CITY OF ALBUQUERQUE

RE: **715, 719, 721 14th St NW**
Grading and Drainage Plan
Engineer's Stamp Date: 4/5/18
Drainage File: J13D208

RE: **715, 719, 721 14th St NW**
Grading and Drainage Plan
Engineer's Stamp Date: 3/20/18
Drainage File: J13D208

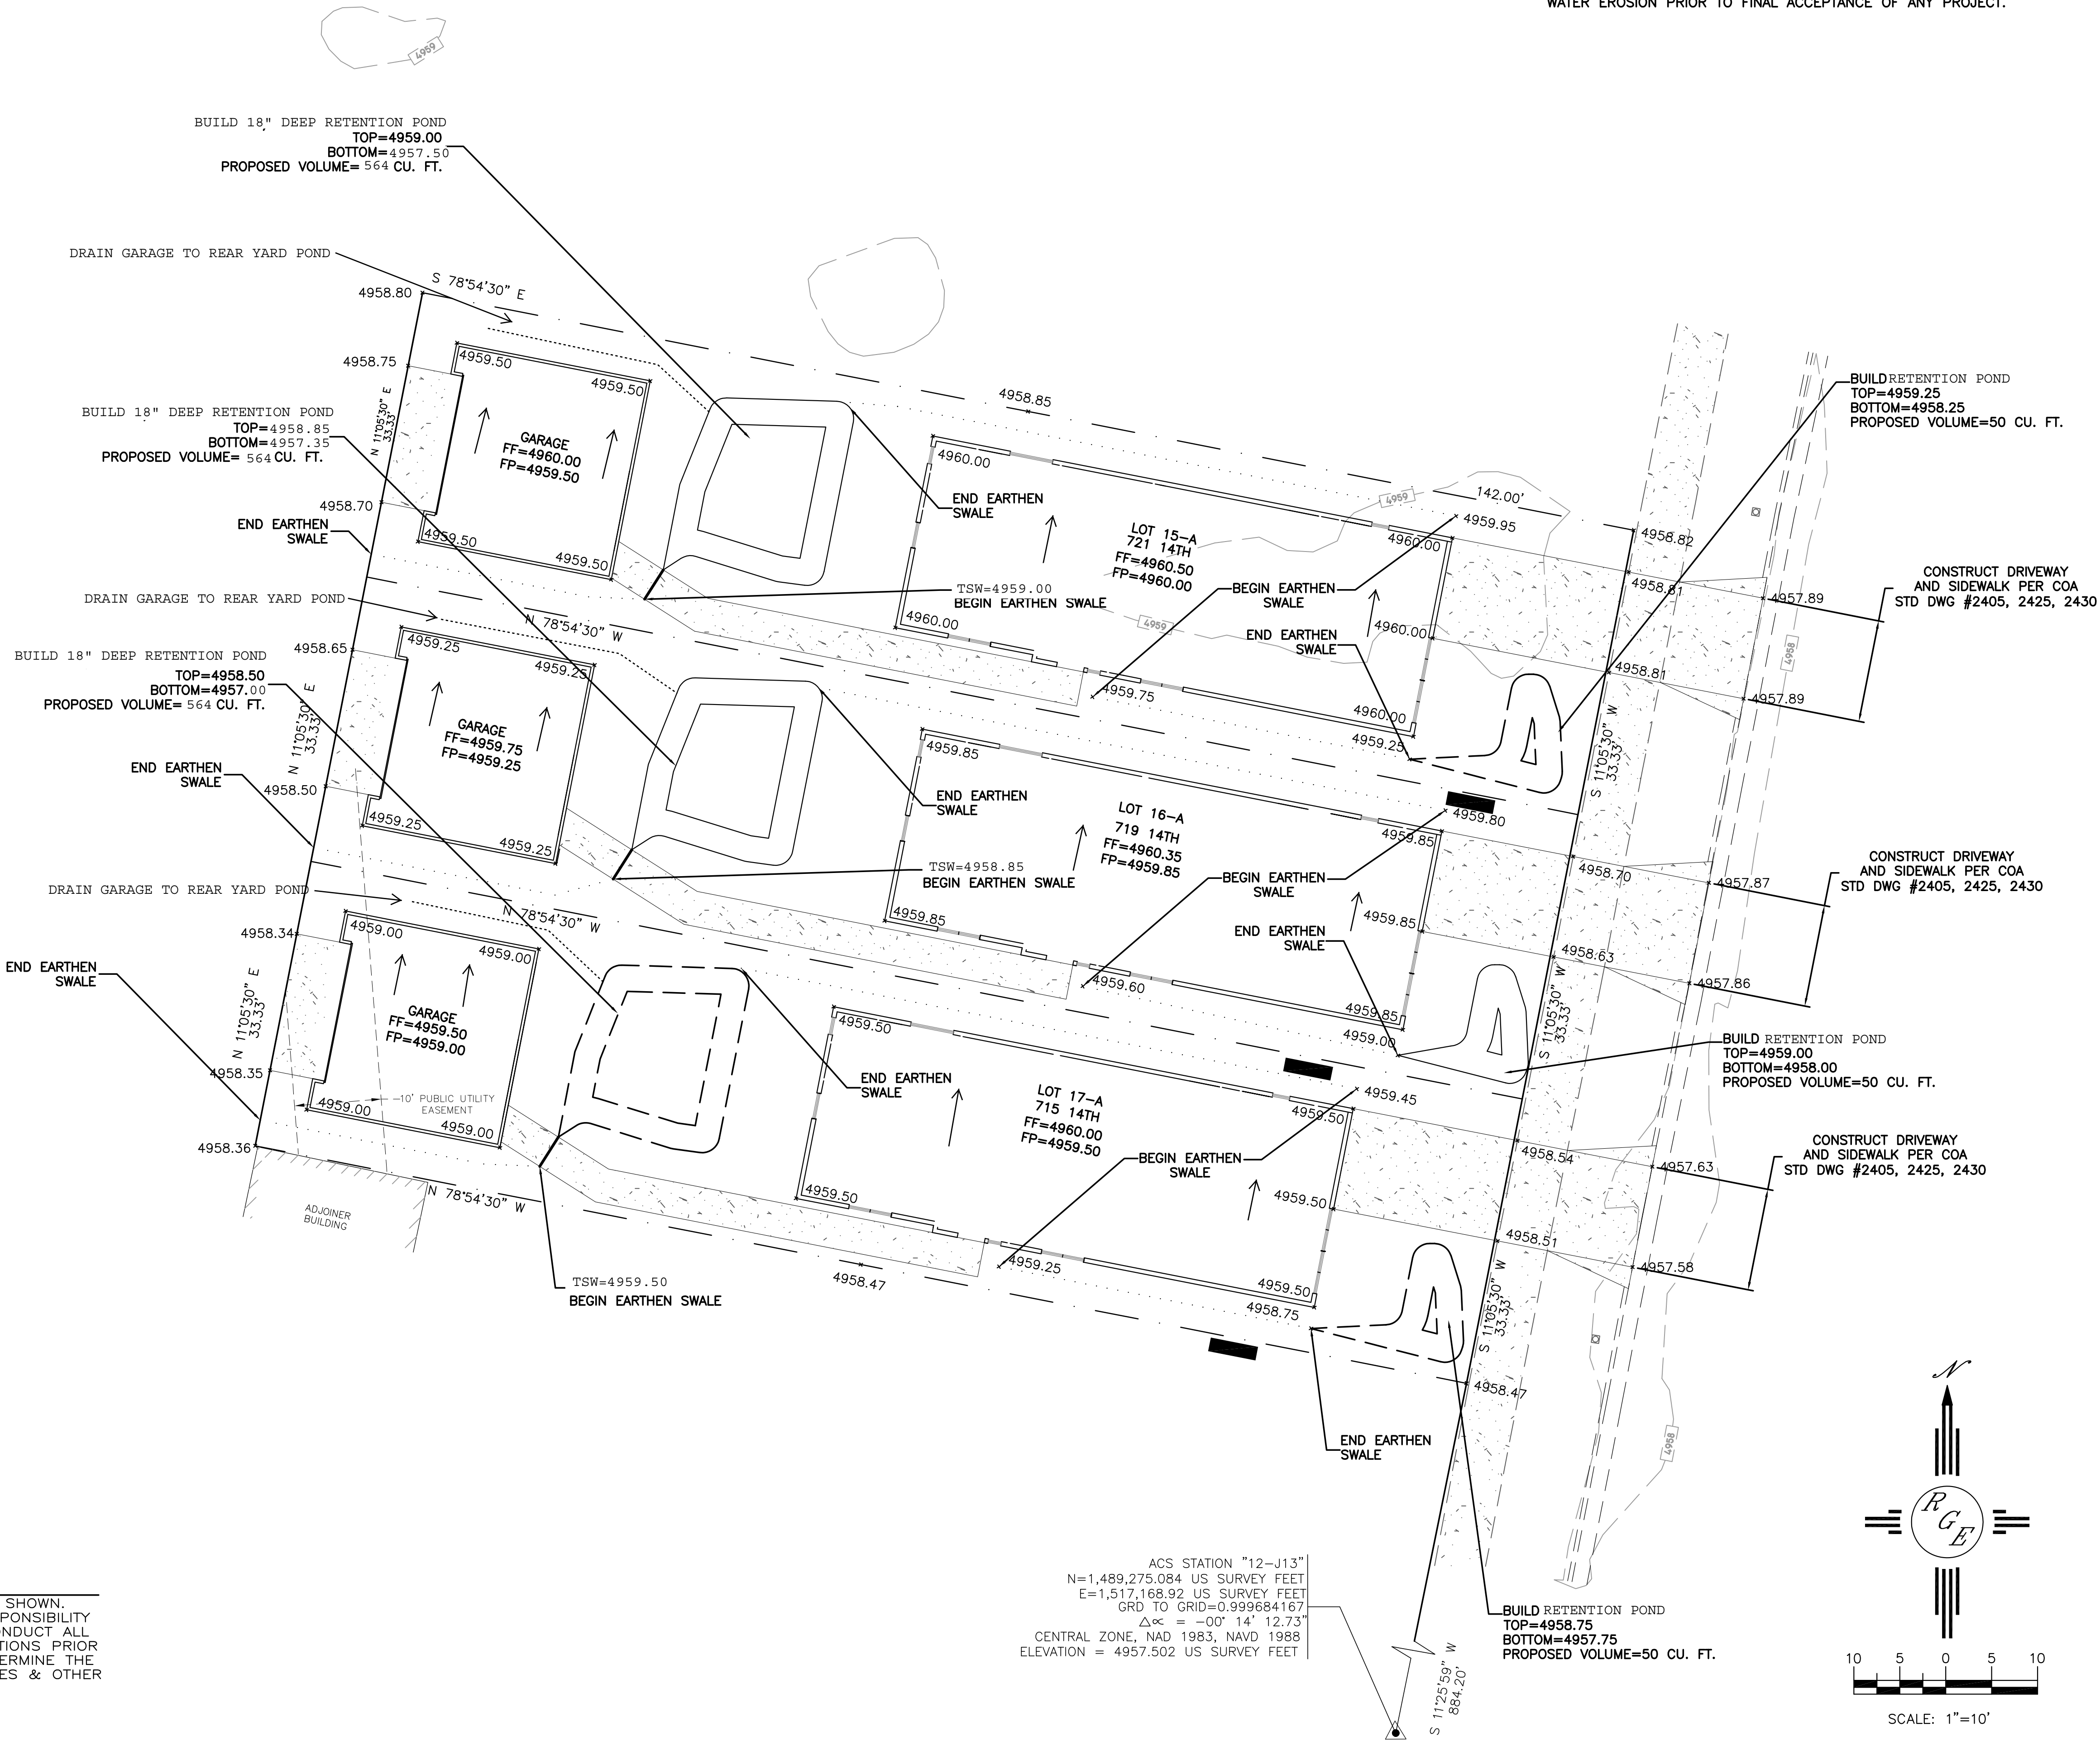
1. Provide onsite ponding volume on each lot for the 100-yr, 6hr volume. **UPDATED**
2. Remove the language relating to first flush. Minor residential subdivisions (less than 10 units) and single residences are exempt from the requirement. **REVISED**
3. Provide all calculations on a stamped plan sheet or in a bound and stamped report; loose calculations cannot be accepted. **PROVIDED STAMPED CALCULATION SHEET**

4. Pad Certifications will be required prior to Hydrology approving the residential Building Permits. **ACKNOWLEDGED**

5. Engineer's Certification, per the DPM Checklist, will be required to ensure the ponds remained intact following home construction.
ACKNOWLEDGED
